DOCUMENT CHANGE REQUEST

DCR number 846	Changes required for: General	Originator: Alain Mouton
Date: 2014/10/13	Date sent: 2014/03/04	Organisation: Astrium
Status: IMPLEMENTED

Title:	Generic Specification for Discrete Microwave Semiconductor Components		
Number:	5010	Issue:	1

charts III(a) and III(b)

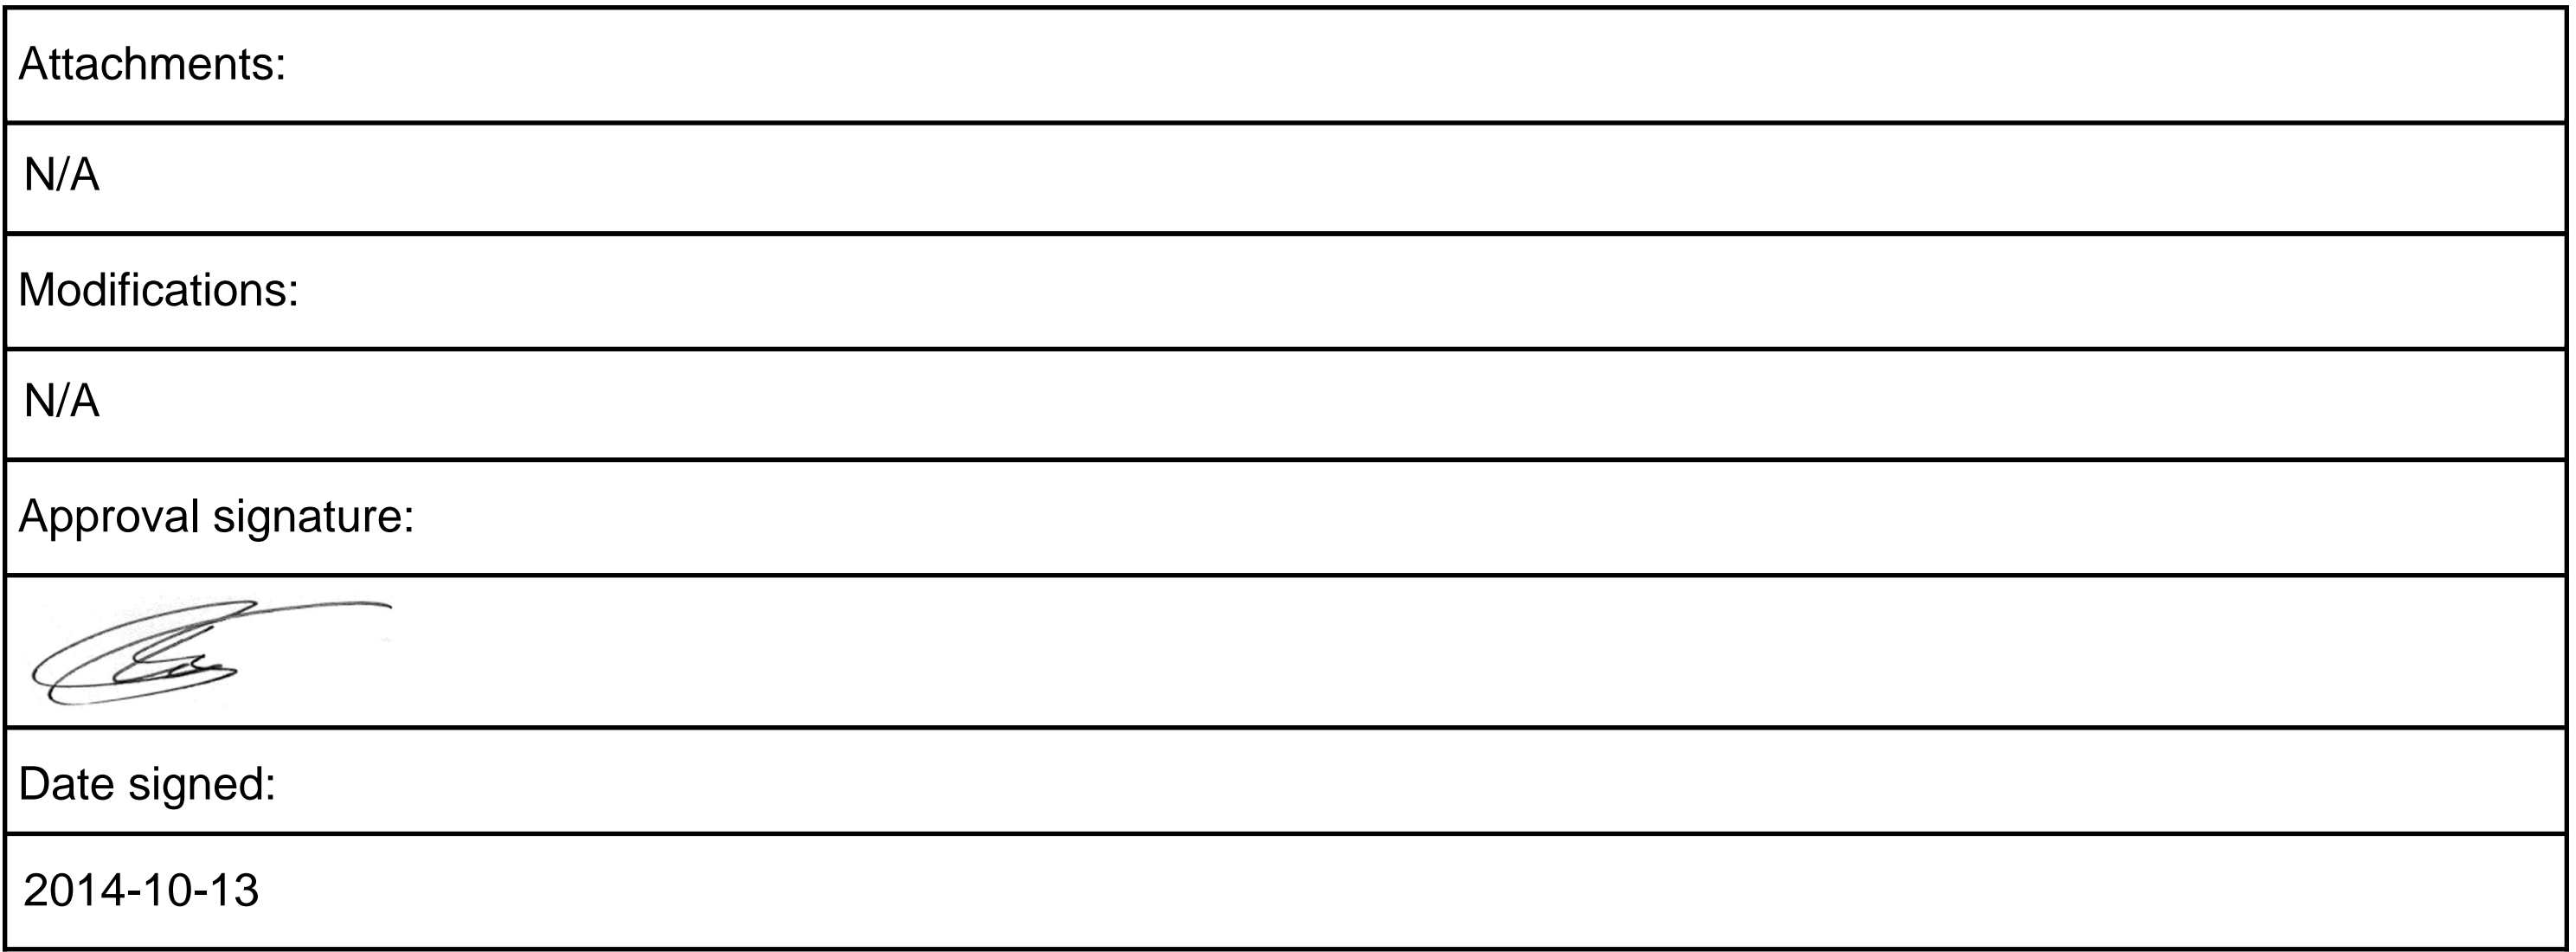
As for ESCC 5000 (DCR 147) and ESCC 9000 (DCR 148), in charts III(a) and III(b), a box "Hot Solder Dip (if applicable)" shall be added after "Electrical Measurements at Room Temperature" and before "Electrical Measurements at High and Low Temperatures".

In page 24, a note (8) shall be added stipulating "For components with hot solder dip final lead finish, the hot solder dip processing shall be performed at any time prior to High an Low Temperatures Electrical Measurements during Screening Tests. The requirements for hot solder dip are specified in ESCC Basic Specification No. 23500.
